| Project | IEEE 802.16 Broadband Wireless Access Working Group < http://ieee802.org/16 > | |
| Title | Periodic ranging in Sleep mode | |
| Date Submitted | 2004-03-17 | |
| Abstract | This contribution is to propose the modification of MOB_TRF IND message in order to perform the periodic ranging within sleep interval appropriately. | |

Figure 1. The proposed operation of sleep mode and periodic ranging

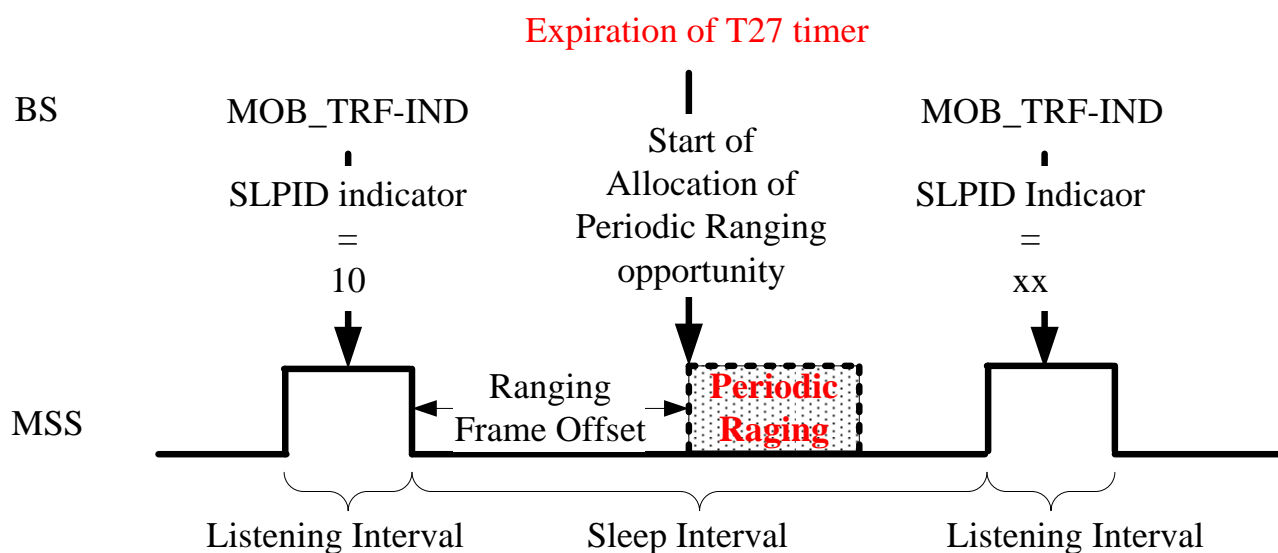
As a way to support both the periodic ranging and the power saving in sleep mode, we modify the MOB_TRF-IND message as followings;

- The length of SLPID indicator which has been allocated and designated to a single MSS is expanded to 2bits from 1bit in order to represent both the periodic ranging and the traffic indication
- 10bits for ranging frame offset is added in order to indicate the opportunity of the periodic ranging for the MSS

If MSS finds that there will be a periodic ranging opportunity within next sleep window, then, it may return to sleep mode until the start of periodic ranging operation apart from the end of the negotiated listening interval as its own Ranging Frame Offset, and

it shall awaken to decode the UL-MAP for periodic ranging opportunity. Upon completion of Periodic ranging operation, it may return to sleep mode if not passed the sleep interval or remain in awake mode based on its two-bit indicator in the SLPID bit-map.
